RFTMA26-5334 - New School Construction Mayfield West No. 2 Public School

PROJECT NO. 24112

ADDENDUM NO. 4

July 28, 2026

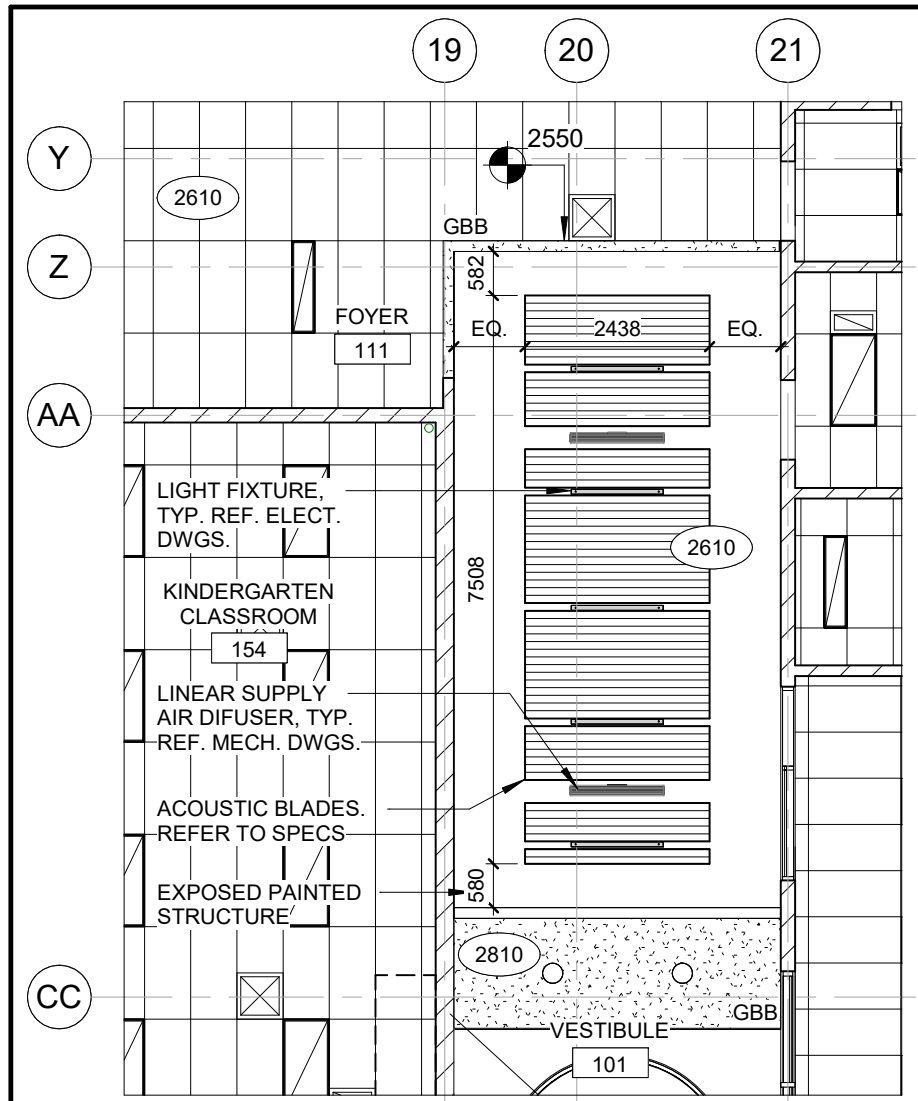
- .1 REVISE layout of acoustic blades at FOYER 111 per enclosed SKA A-200 FOYER 111 - ACOUSTIC BLADES LAYOUT, dated July 27, 2026. Attached.

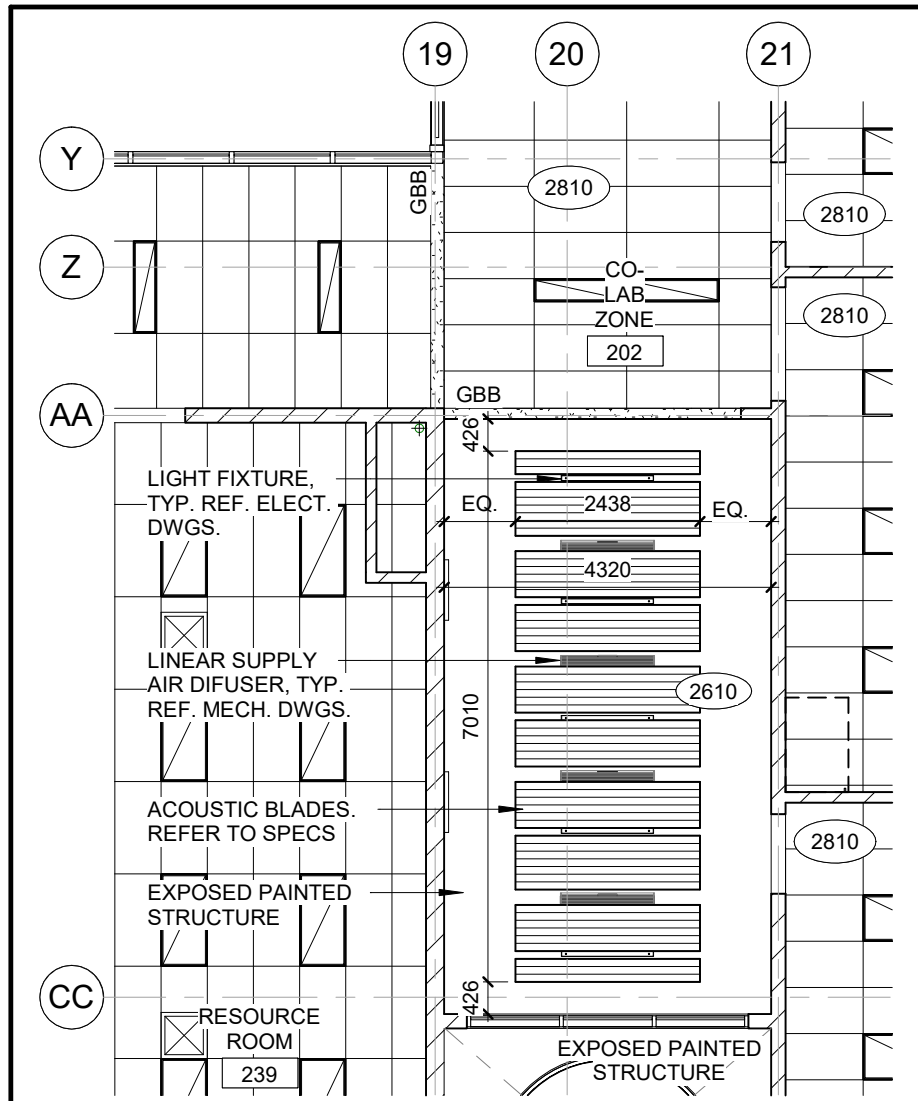
- .1 REVISE layout of acoustic blades at CO-LAB 202 per enclosed SKA A-201 CO-LAB 202 - ACOUSTIC BLADES LAYOUT, dated July 27, 2026. Attached.

BULK EXCAVATION PLAN

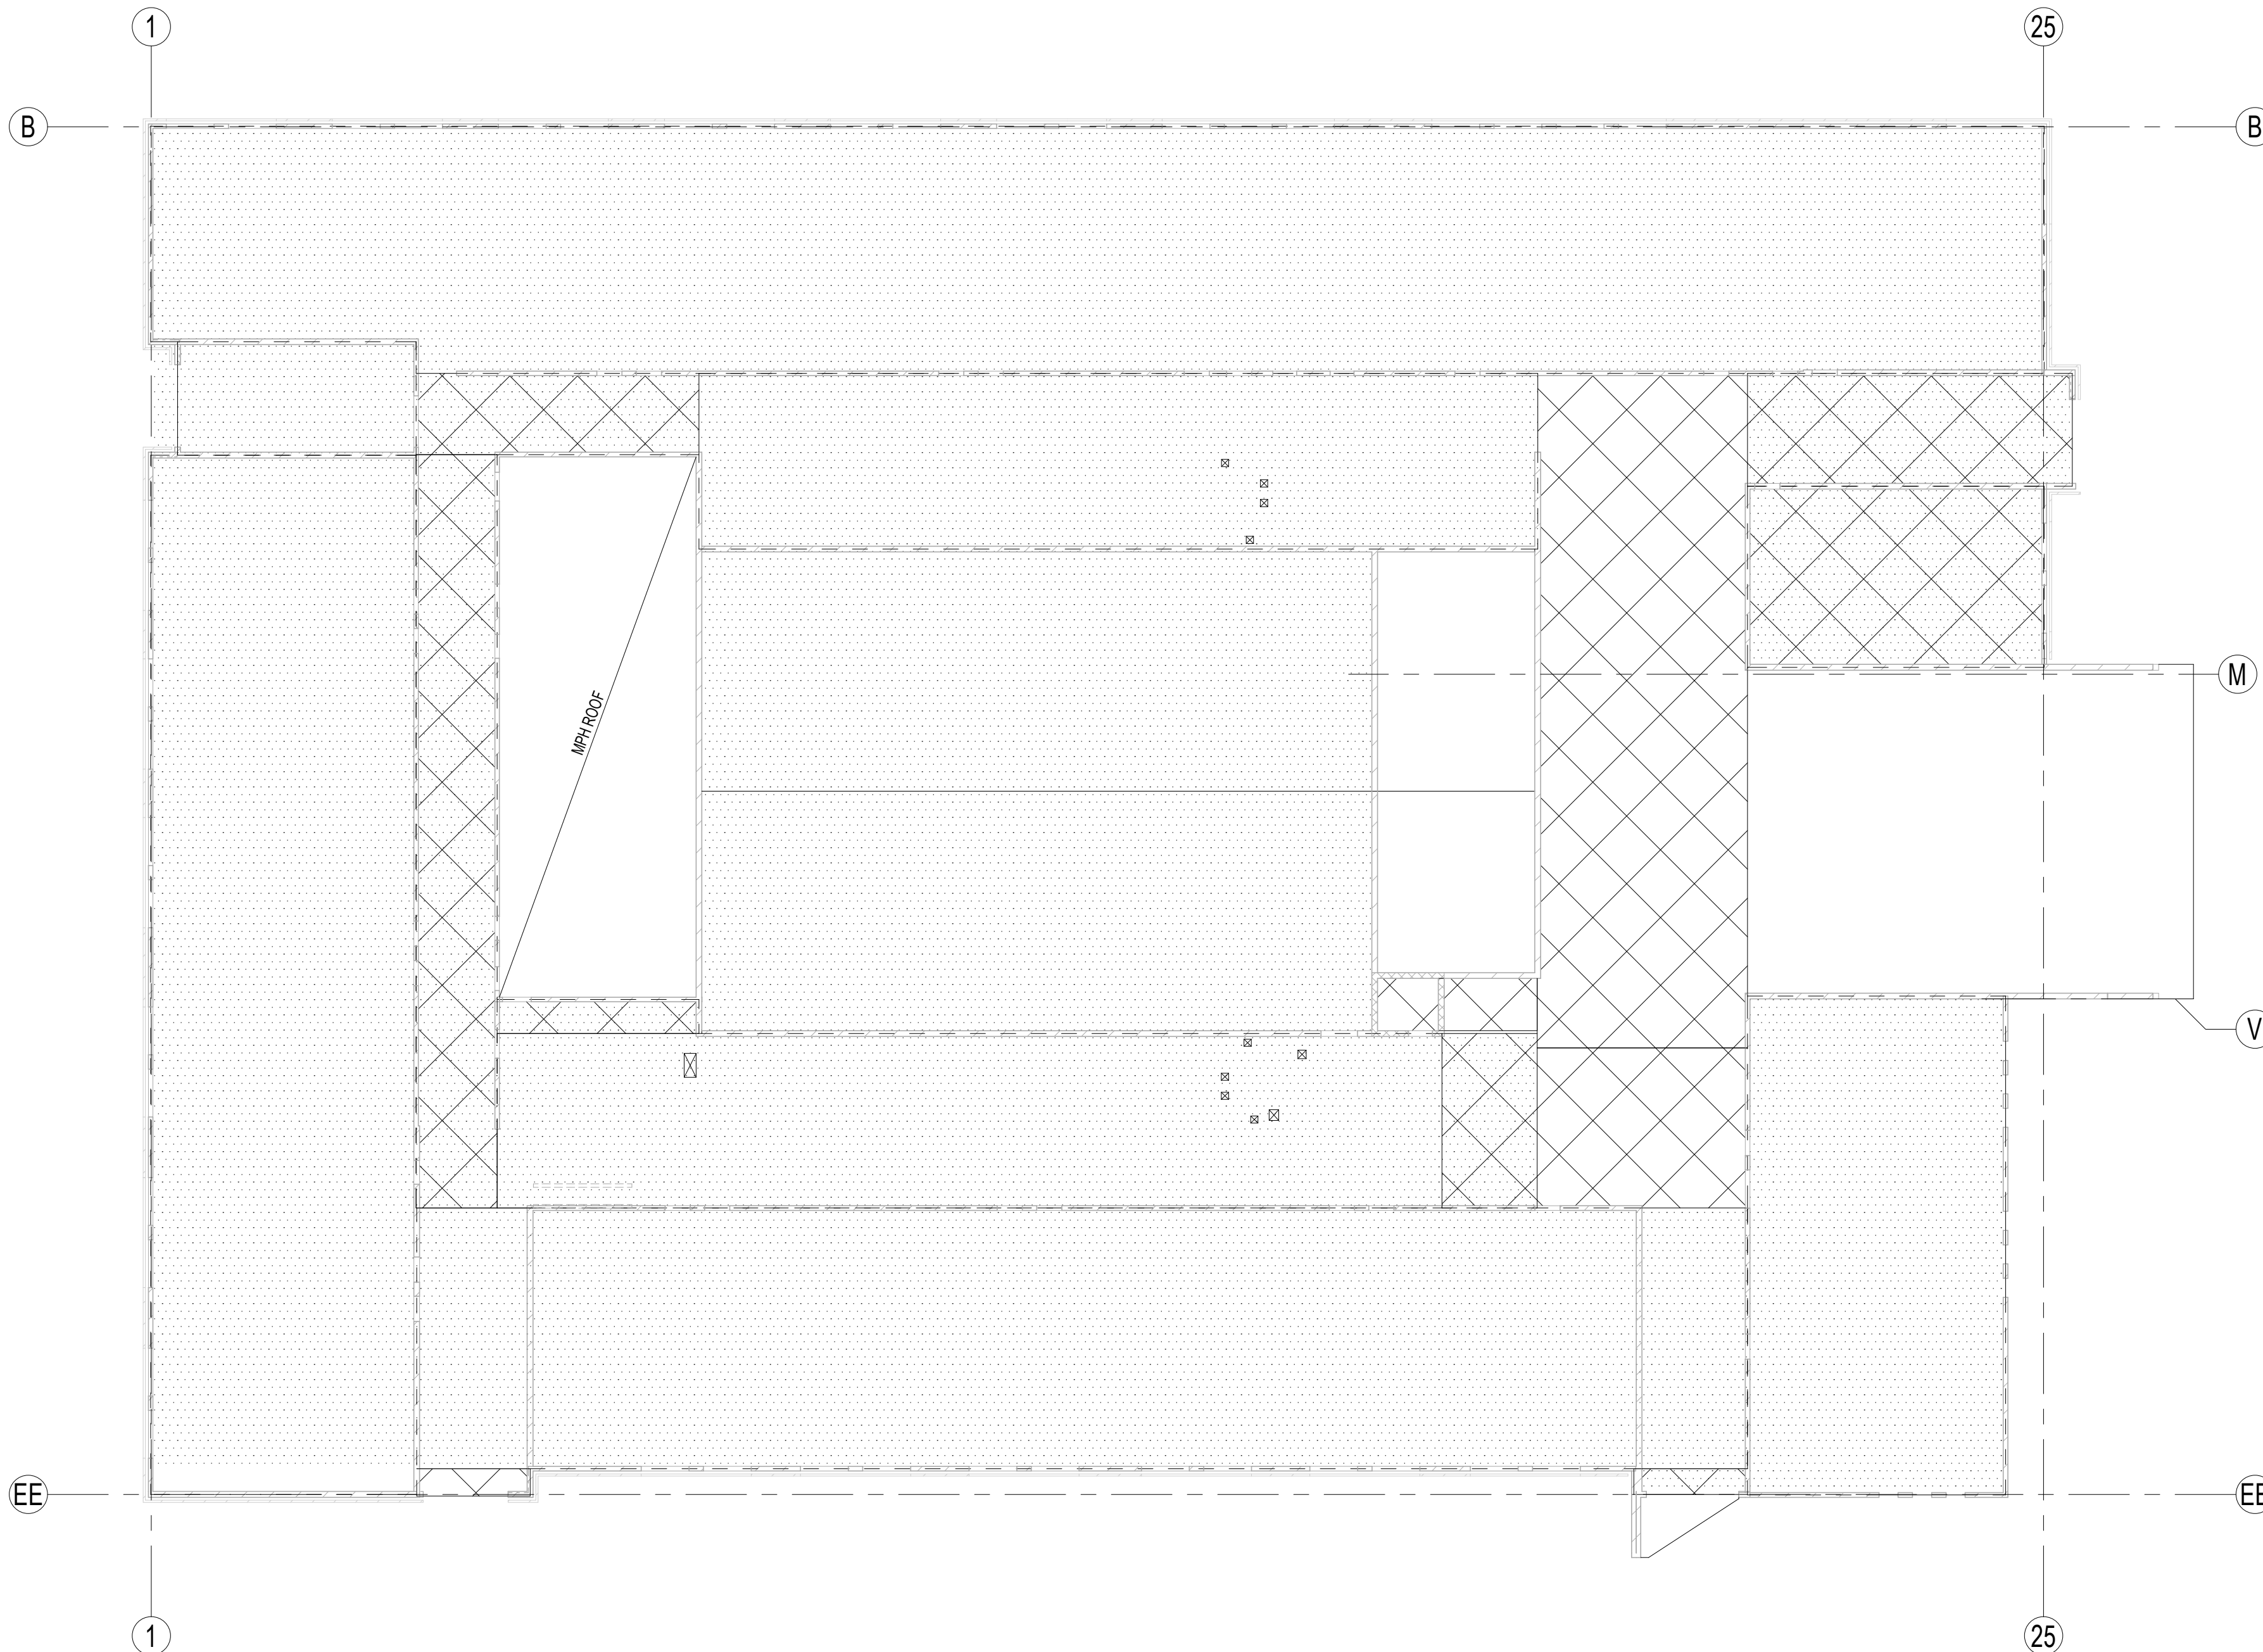
- .1 Bulk excavation plan revised to suit revised gradings within the borehole loads of the revised geotechnical report. See clouded areas and notes.

PLUMBING & DRAINAGE - GROUND FLOOR PLAN

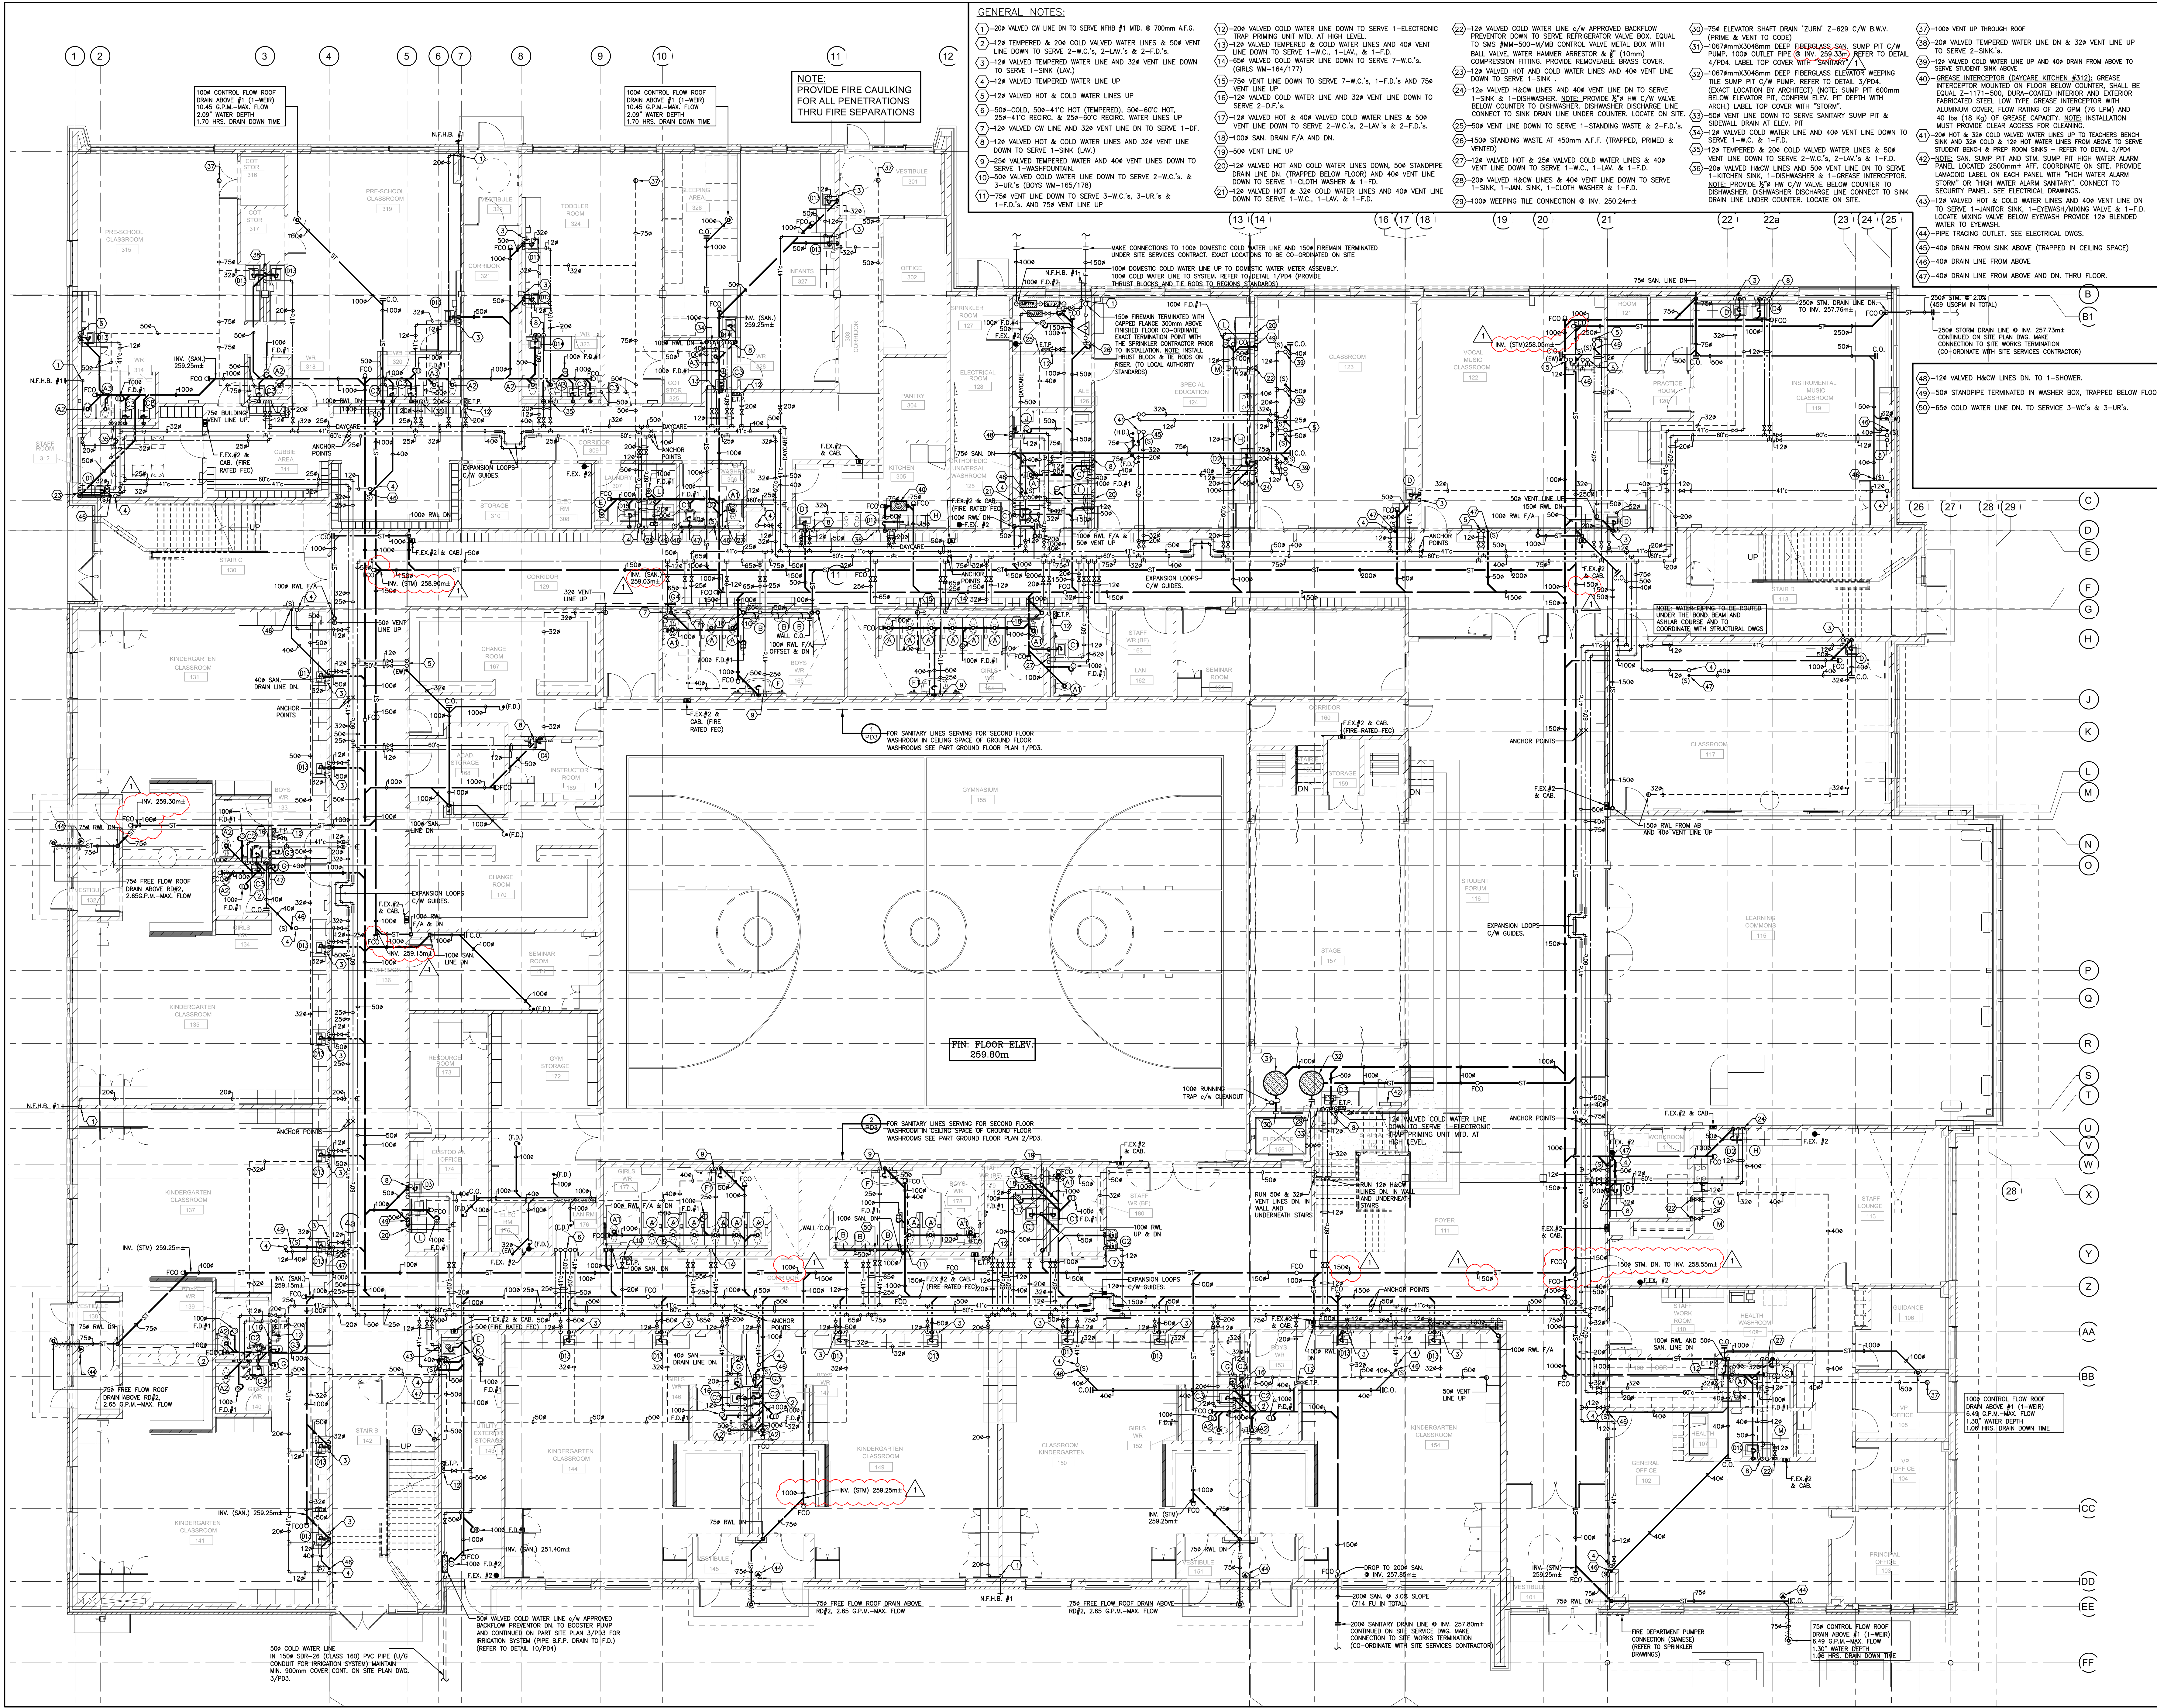
QUESTION 17: Drawing PD1 – notes the storm invert at gridlines (E/5) to be 250.90. Please confirm this invert as the invert at gridlines (Y/2) is 259.25. Please clarify the storm is not to be 8.9m below FFE.

- 1 Revise and add storm drain, sanitary drain inverts, and change storm drain pipe sizes as shown on drawing.
